ADDENDUM No. 2
SECTION 00 91 13

PROJECT: **PROJECT OFFICE BUILDING,
RENOVATION OF EXISTING BUILDING, AND
SITE IMPROVEMENTS AT FOXWORTH,
MARION COUNTY, MISSISSIPPI**

PROJECT NUMBERS: **BWO-7149-46(001) 502689**
BWO-7079-46(003) 502689
LWO-7061-46(003) 502689

DATE: **APRIL 15, 2016**

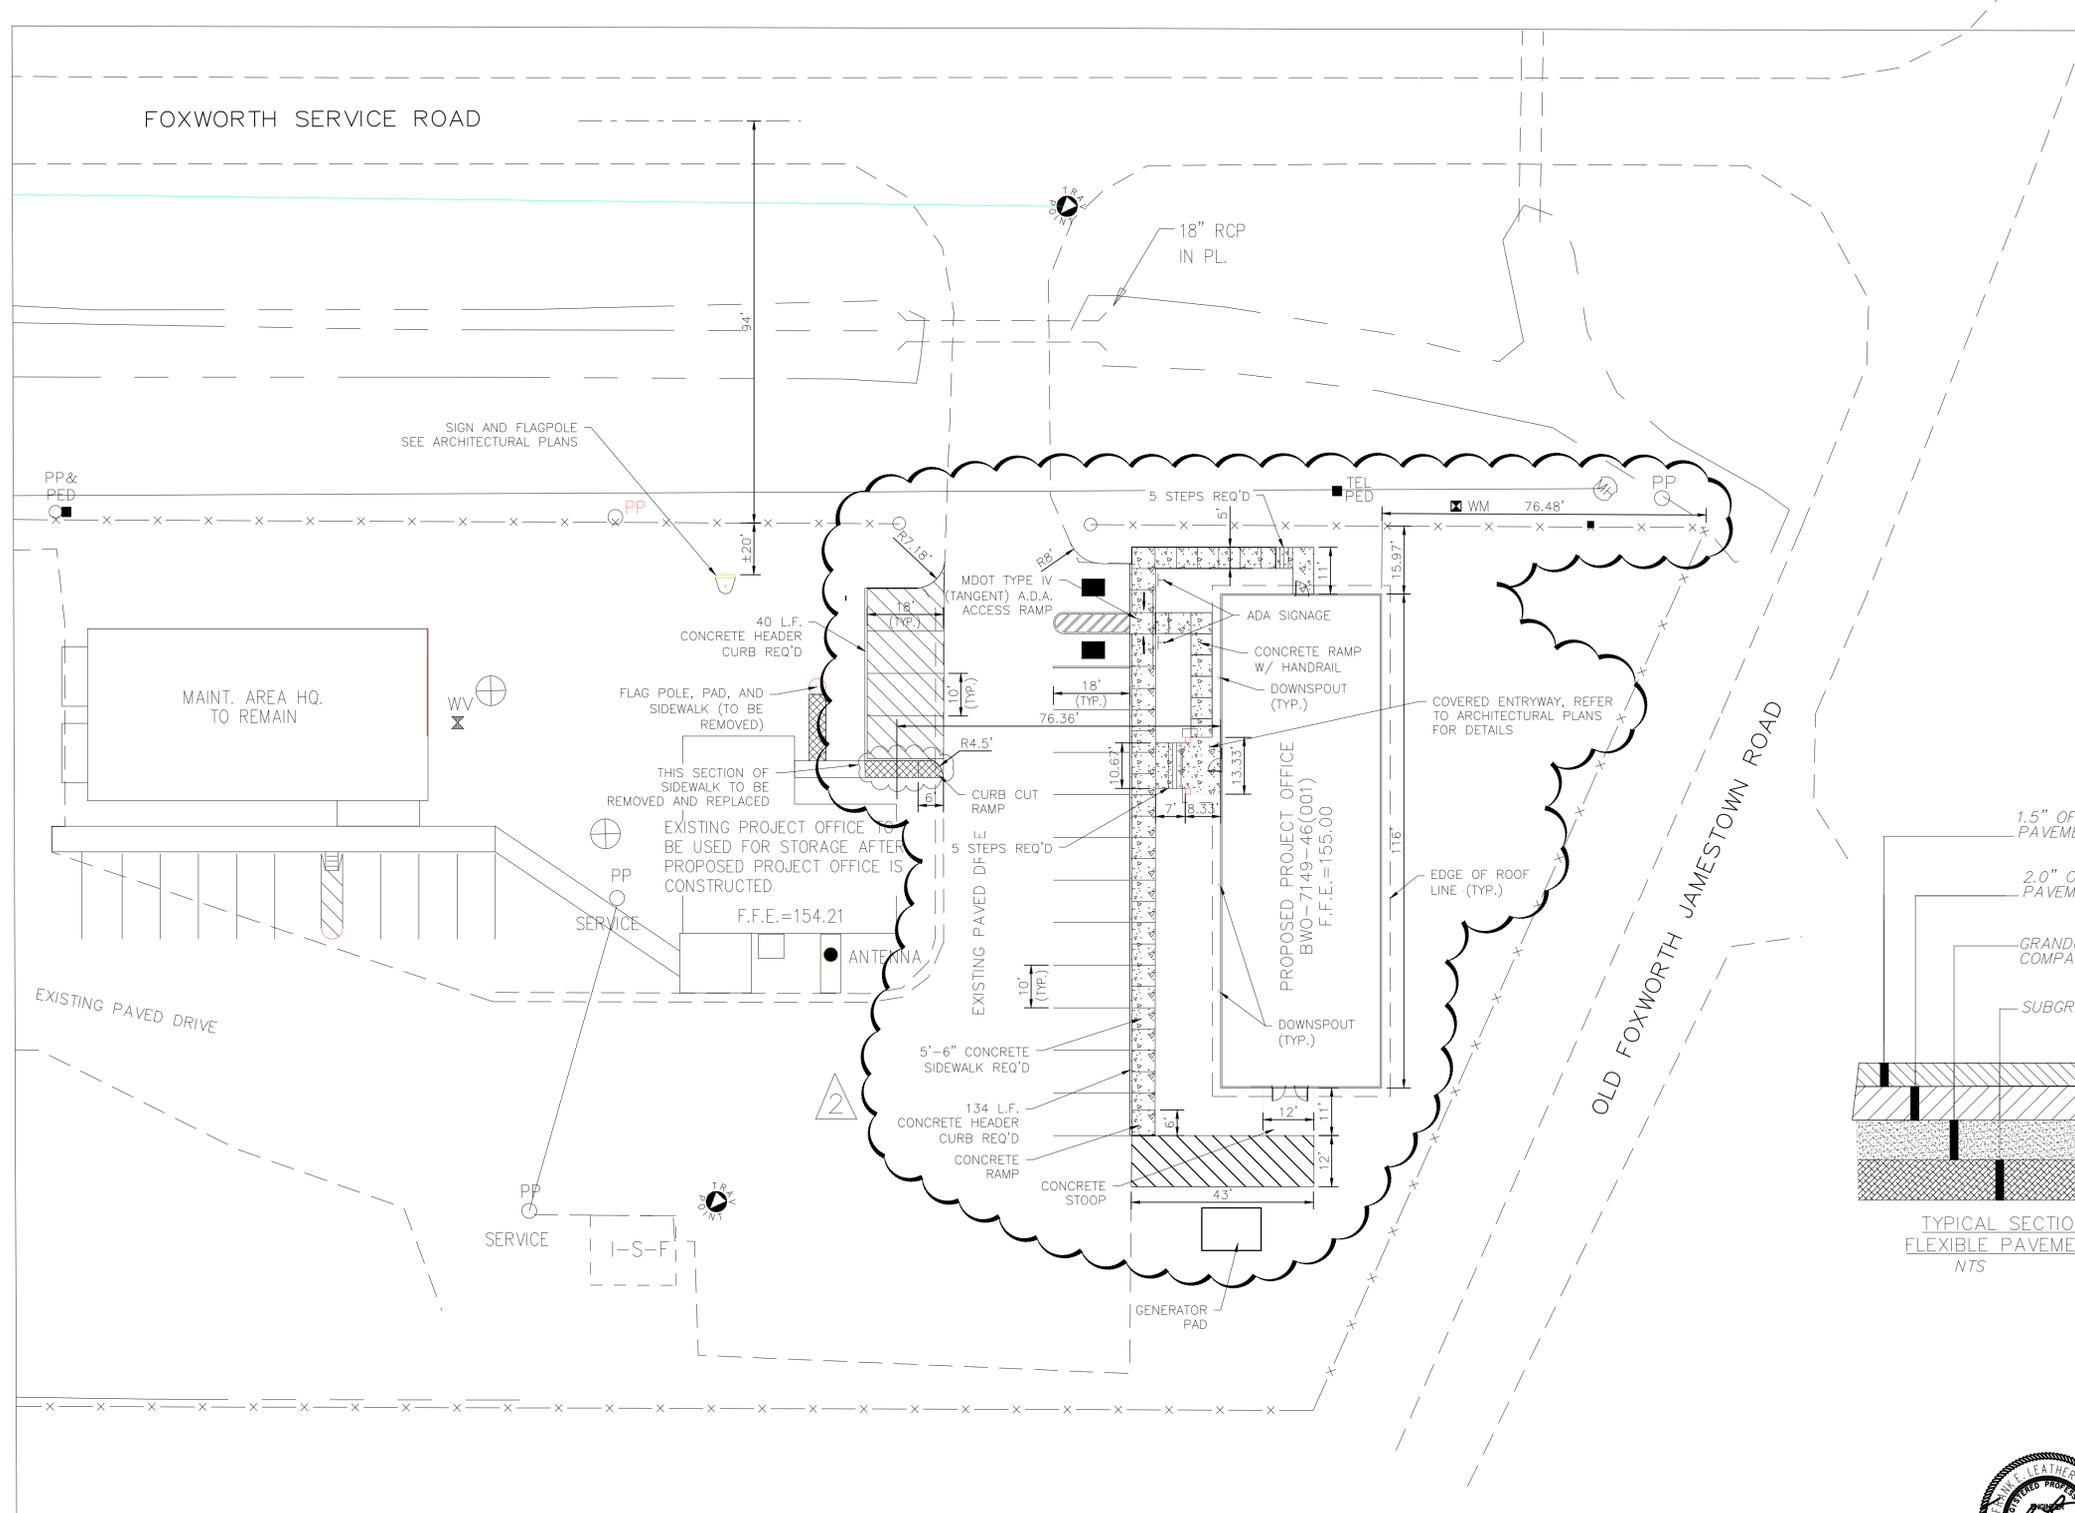
B. The following revisions have been made to Working Number C1.2, Sheet Number 4:

1. Revision to note number 3.

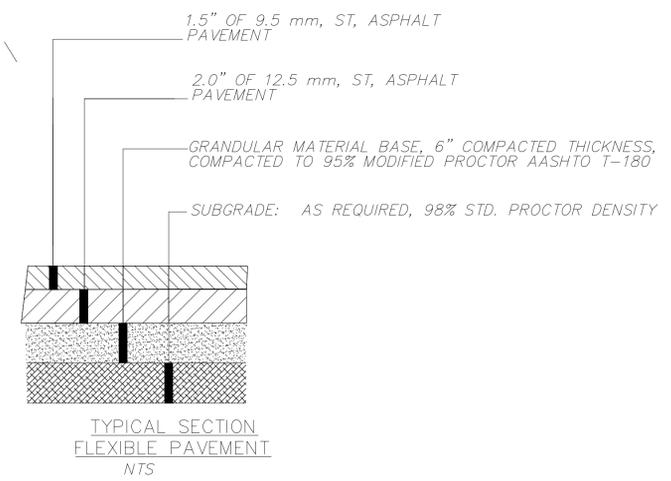
C. The following revisions have been made to Working Number C1.3, Sheet Number 5:

1. Revision of sidewalk and building and add handicap ramp and steps.

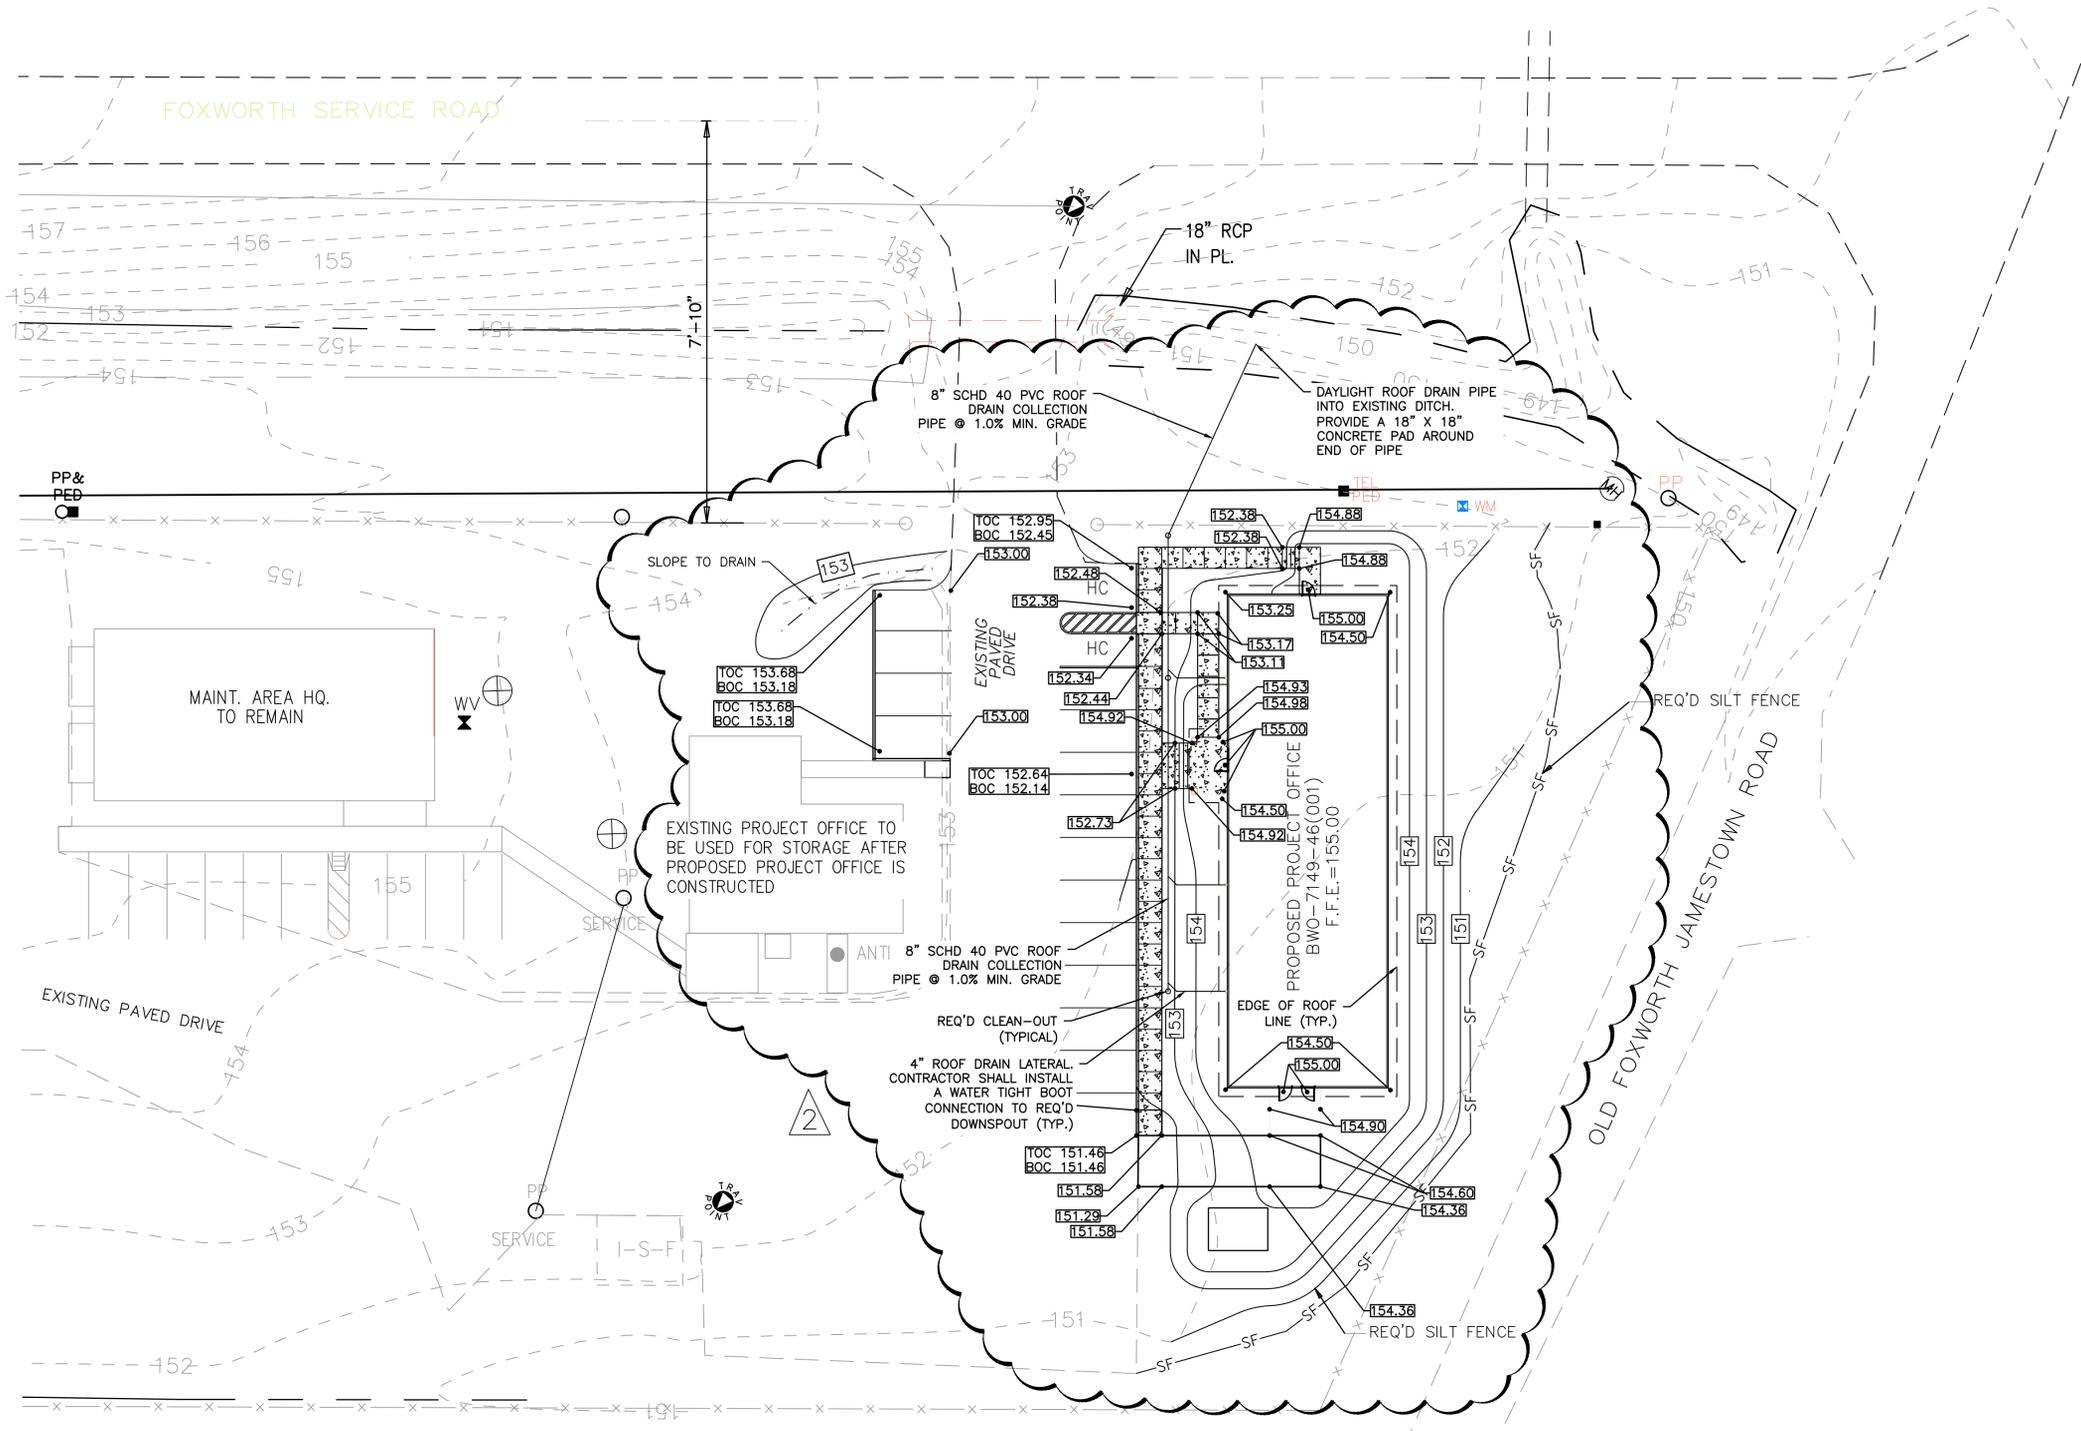
D. The following revisions have been made to Working Number C1.4, Sheet Number 6:

1. Revision of grades at building and adjacent site improvements.

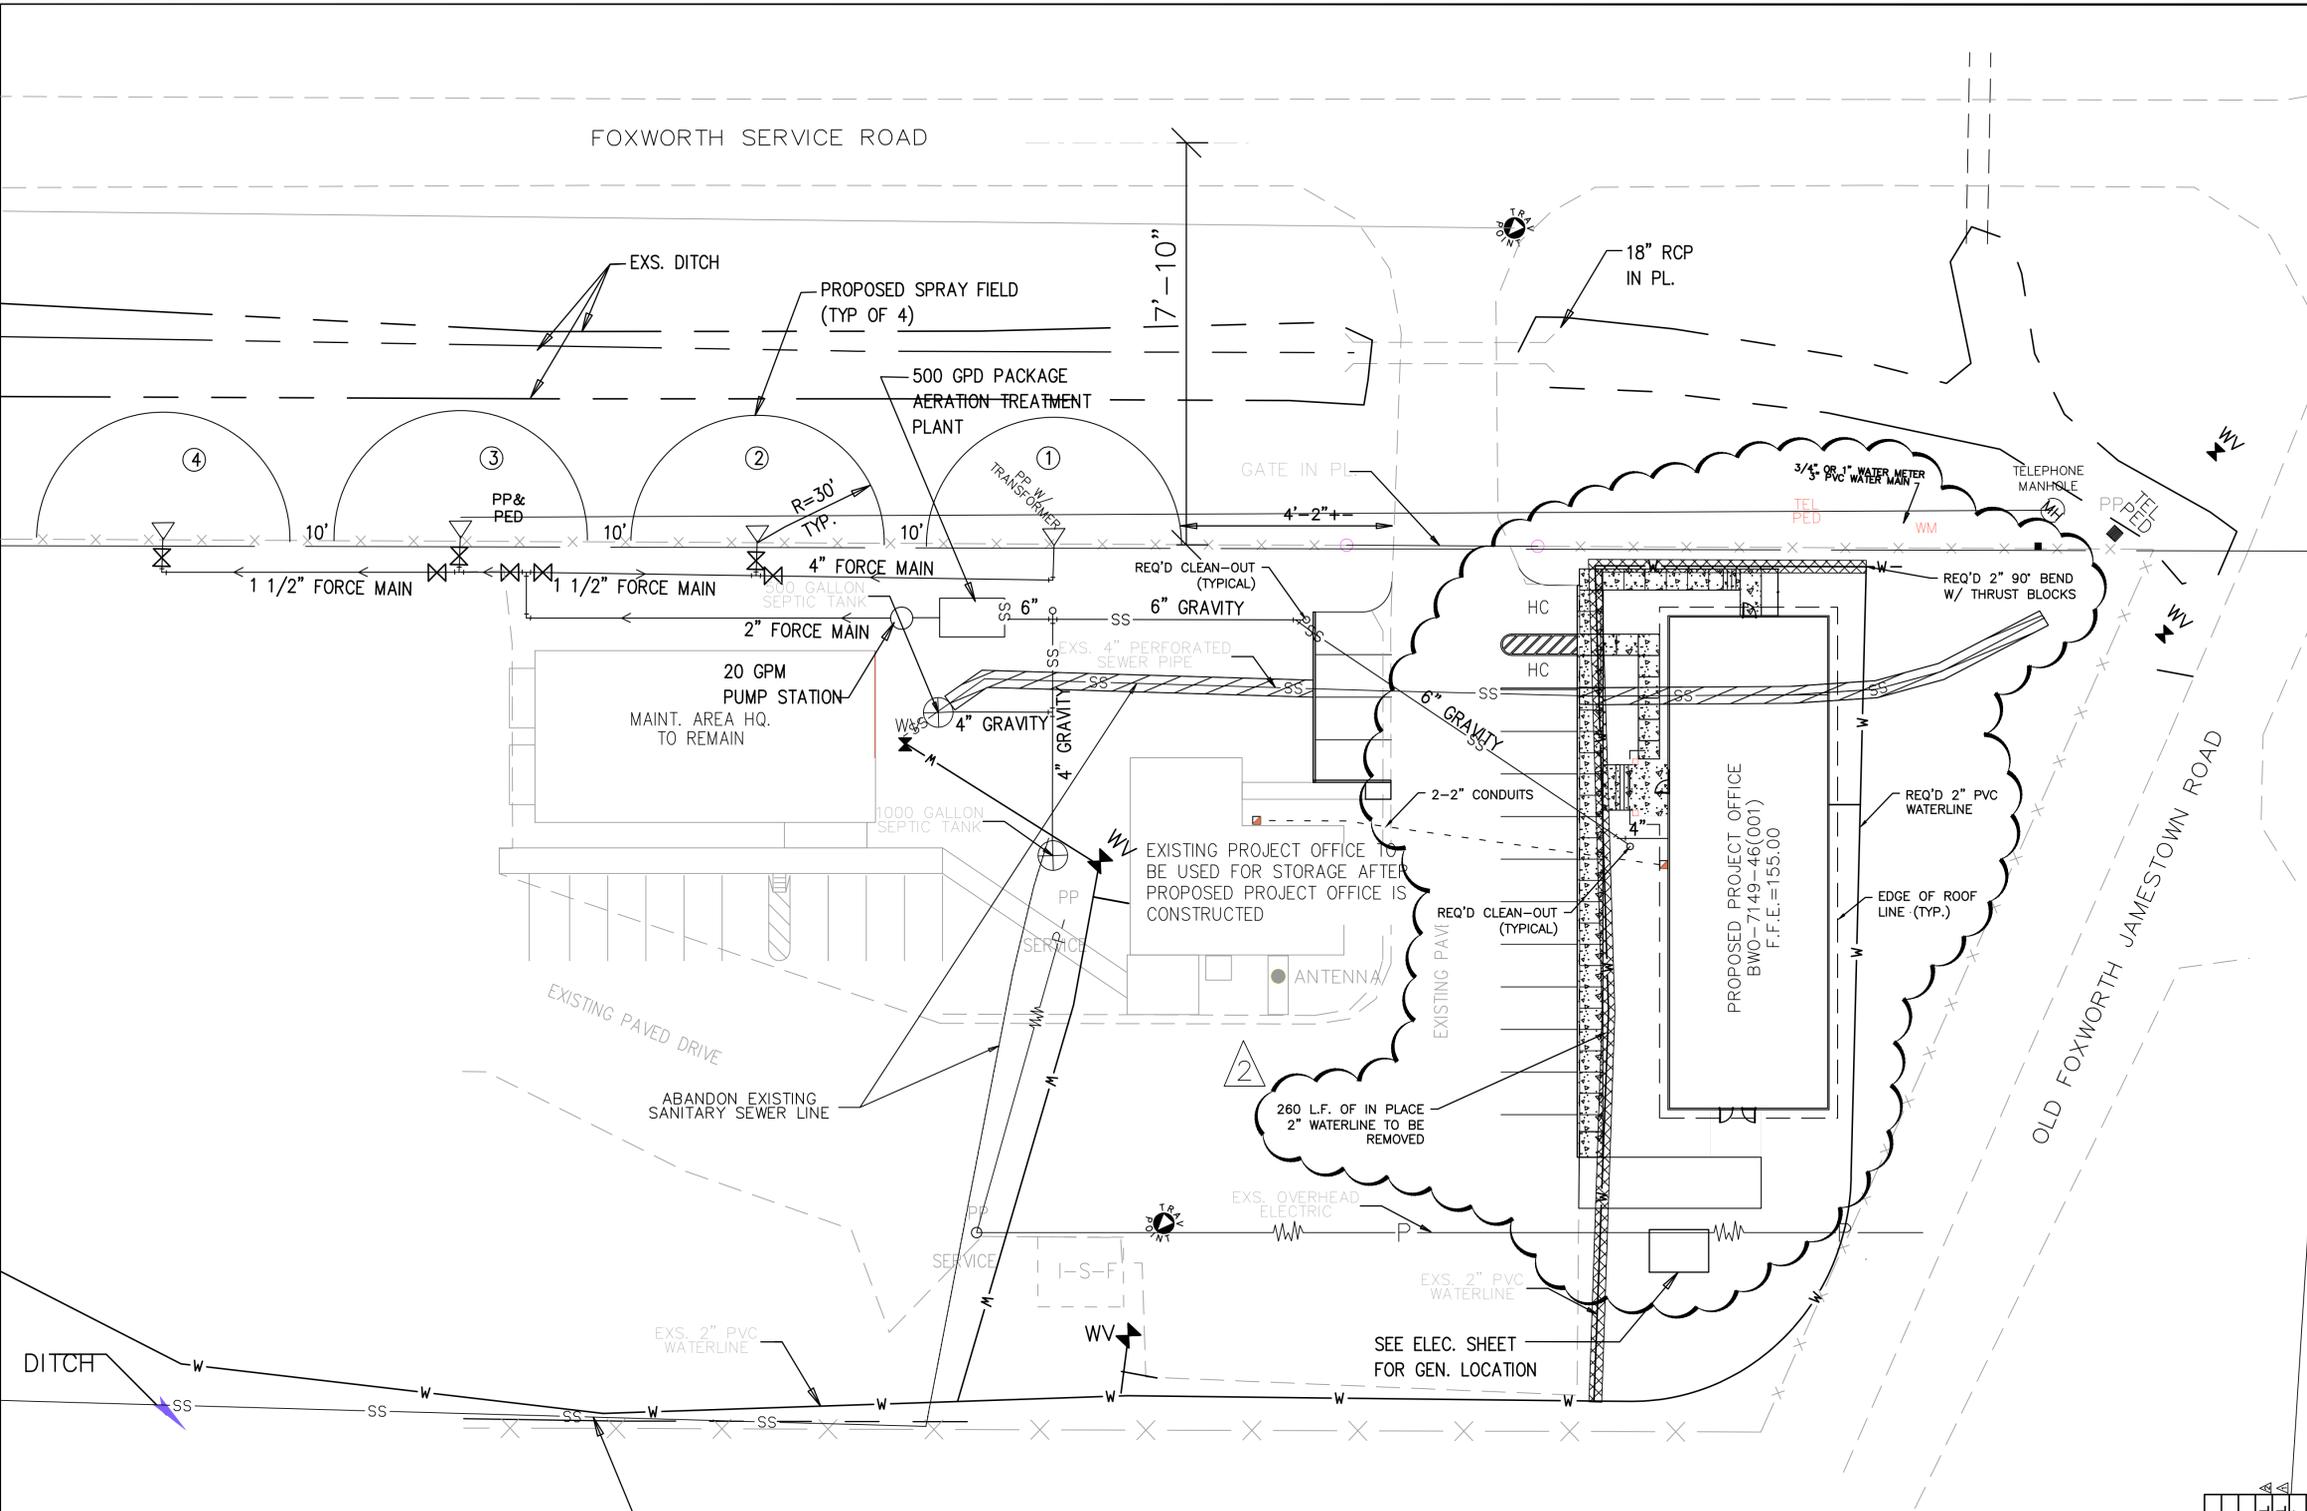
- E. The following revisions have been made to Working Number C1.5, Sheet Number 7:
 - 1. Revisions to utilities servicing building.
- F. The following revisions have been made to Working Number C1.6, Sheet Number 8:
 - 1. Added step, handicap ramp, and railing details to Drawing.
- G. The following revisions have been made to Working Number A1.1, Sheet Number 12:
 - 1. Revision of building location and addition of steps and handicap ramp to Overall Site Plan.
- H. Working Number S5.2, Sheet Number 25.1 added to Drawings to show detailed plan of handicap ramp and steps with handrails.
